AGENDA
CITY OF TAYLOR, TEXAS
PLANNING & ZONING COMMISSION MEETING
CITY HALL COUNCIL CHAMBERS
400 PORTER STREET
TAYLOR, TX, 76574
MARCH 11, 2025, 6:00 PM

3. Review and approve minutes from the meeting held on February 11, 2025 *Courtney Peres*
4. **PZ-2024-2368** Consider Approval of The Foundry Preliminary Plat, generally located at the intersection of Old Granger Road and North Main Street, legally described as a 10.69-acre tract of land in the J. Pharrass Survey, Abstract No. 495, more particularly described by the Williamson Central Appraisal District Parcel R102540, Taylor, Williamson County, Texas. *Courtney Peres*
5. **PZ-2025-2410** Consider Disapproval of the Heritage Tree Replat, generally located at 1420 Frink Street, Taylor, consisting of approximately 0.513 acres of land, legally described as Frink and Jones Subdivision, Block 1, Lot 1, 2, and part of Lot 3, more particularly described by the Williamson Central Appraisal District Parcel R017128, Taylor, Williamson County, Texas. *Preston Gunn*

6. **PZ-2025-2411** Consider Disapproval of Spring Creek Phase 3 Subdivision Improvement Plan, generally located on County Road 367, consisting of approximately 15.5 acres of la

Figure 2-1 Typical Utility Locations For A Neighborhood Street

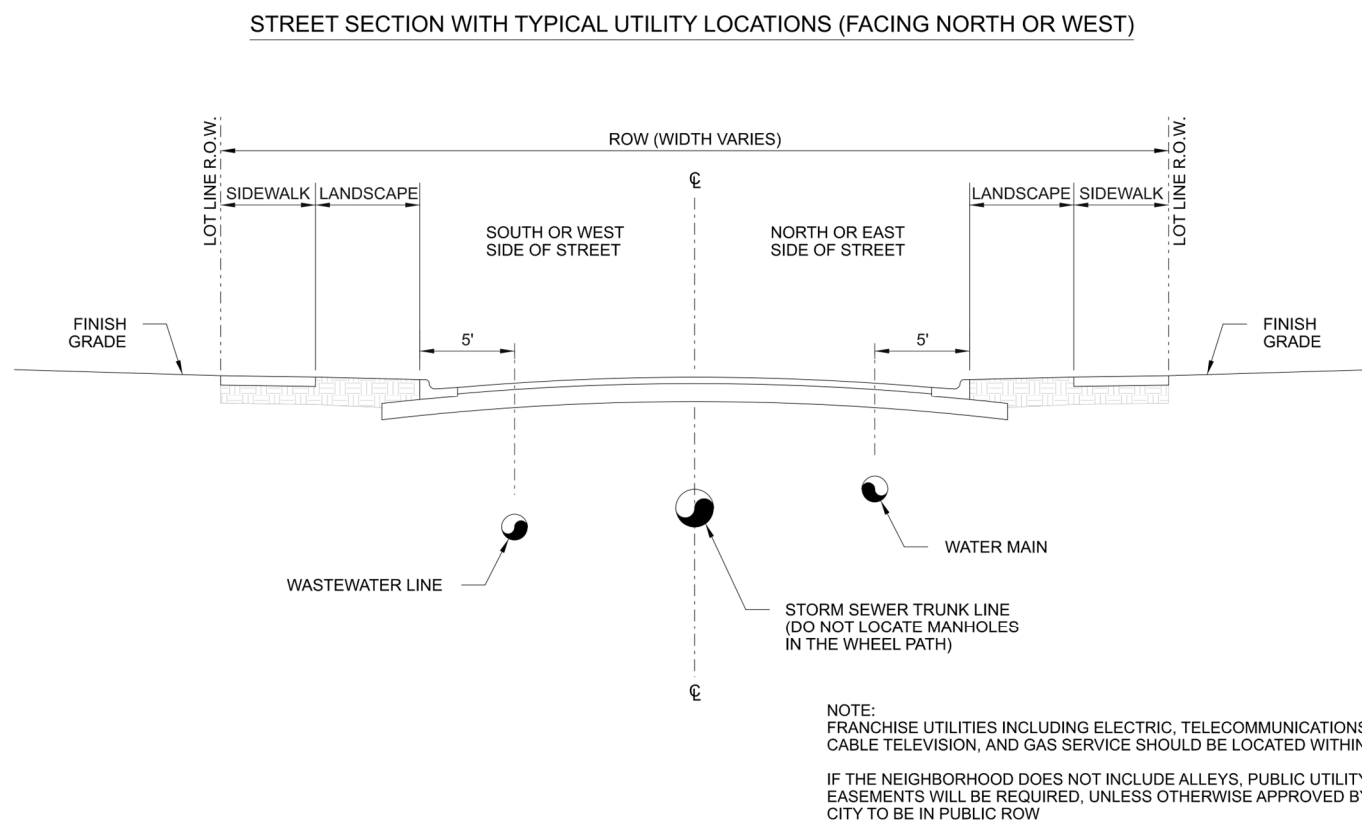
73. Sheet - [22] C4.6 STORM PLAN II - Storm sewer location to be per ROW assignments found in Taylor EM Sec. 2 (see figures 2-1) (Typical, all plan locations)

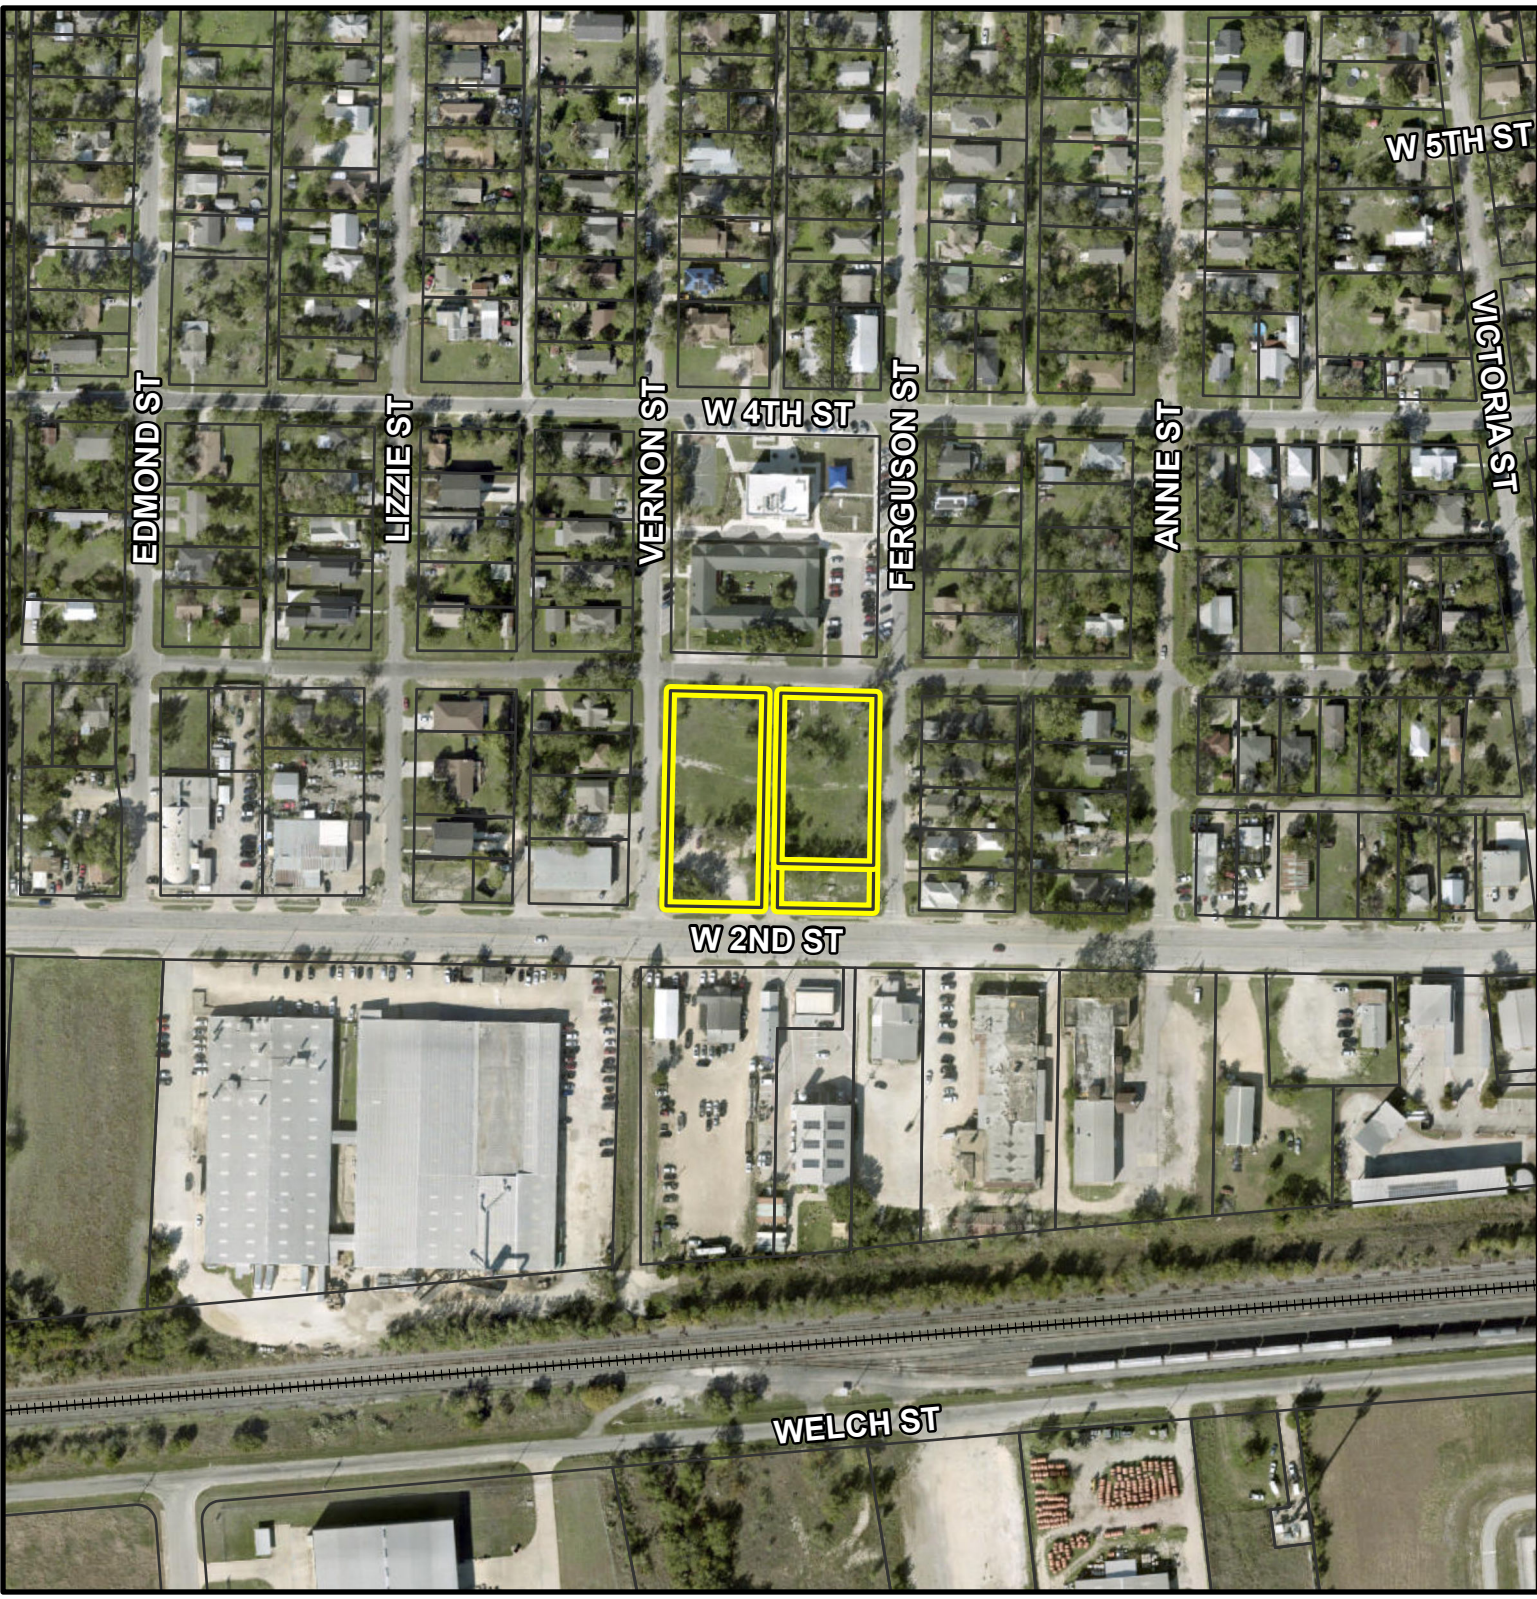
Plat note #7 shall be revised to read: A minimum fire flow shall be provide as per the adopted International Fire Code.

Please revise the plat to address the comments noted above. Following revision, submit the plat electronically with a resolution letter in PDF format.
